**Report: TAB REPORT
Function: Test, Adjust, & Balance
Date: 12/29/2022**

12-26 CULVERS - GREEN BAY, WI (FACILITY TAB)

Project Issue Information

Issue Name : 1. PRV-1 (Restrooms) Fan is Not Operational.

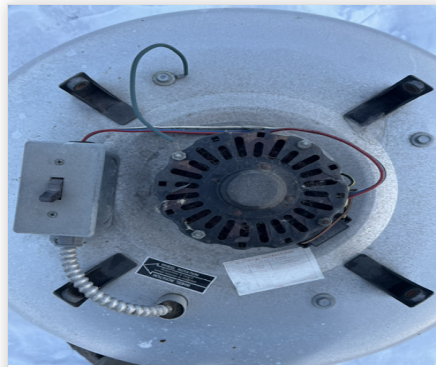
Description : Fan is not operational. Motor may need replacement. Recommend service.
